**Addendum / Addenda**

No./N<sup>o</sup>  
2

Project Description / Description de projet		
EME Vancouver - Maintenance Shop and Laboratory 1403 Renovations		
Solicitation No./ No de sollicitation	Project No./N <sup>o</sup> de projet	W.O. No./N <sup>o</sup> d'ordre de travail
14-22091	4063	A1-005632-01-01
Departmental Representative / représentant ministériel		Date
John Yuen		Dec 9 <sup>th</sup> 2014
<p><b>Notice:</b> This addendum shall form part of the tender documents and all conditions shall apply and be read in conjunction with the original plans and specifications.</p>		<p><b>Nota:</b> Cet addenda fait partie intégrale des dossiers d'appel d'offres; toutes les conditions énoncées doivent être lues et appliquées en conjonction avec les plans et les devis originaux.</p>

This addendum #2 is a further clarification of addendum #1

DESCRIPTION  
**MECHANICAL ROOM, ELEVATION AND SCHEMATIC**

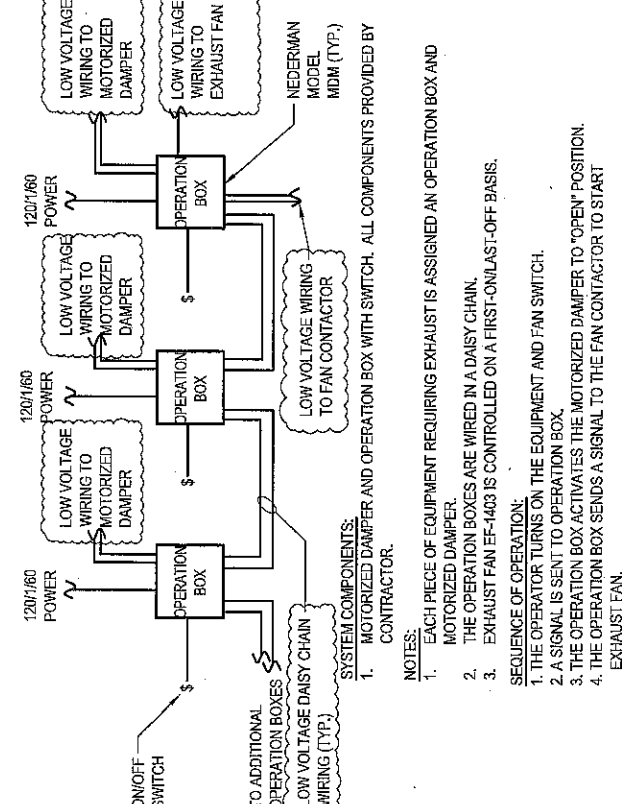
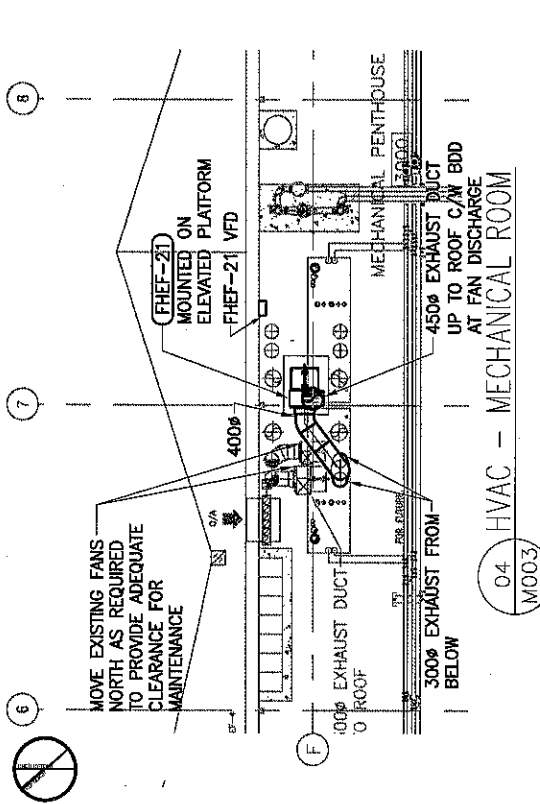
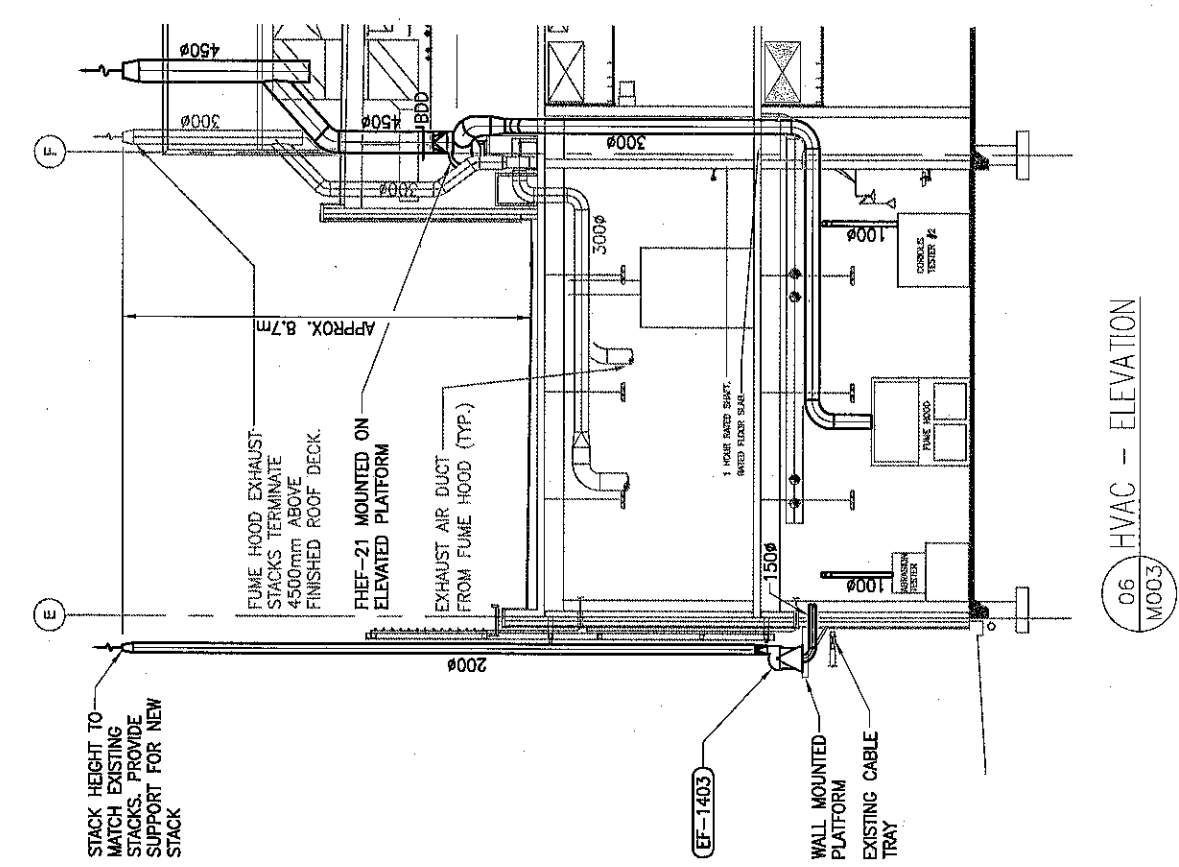
Replace originally issued Dwg 1407 M-003 and 1409 M-002 with new attached revised versions

NOTES:  
 1. EACH PIECE OF EQUIPMENT REQUIRING EXHAUST IS ASSIGNED AN OPERATION BOX AND MOTORIZED DAMPER.  
 2. THE OPERATION BOXES ARE WIRED IN A DAISY CHAIN.  
 3. EXHAUST FAN EF-1403 IS CONTROLLED ON A FIRST-ON/LAST-OFF BASIS.  
 SEQUENCE OF OPERATION:  
 1. THE OPERATOR TURNS ON THE EQUIPMENT AND FAN SWITCH.  
 2. A SIGNAL IS SENT TO OPERATION BOX.  
 3. THE OPERATION BOX ACTIVATES THE MOTORIZED DAMPER TO "OPEN" POSITION.  
 4. THE OPERATION BOX SENDS A SIGNAL TO THE FAN CONTACTOR TO START EXHAUST FAN.
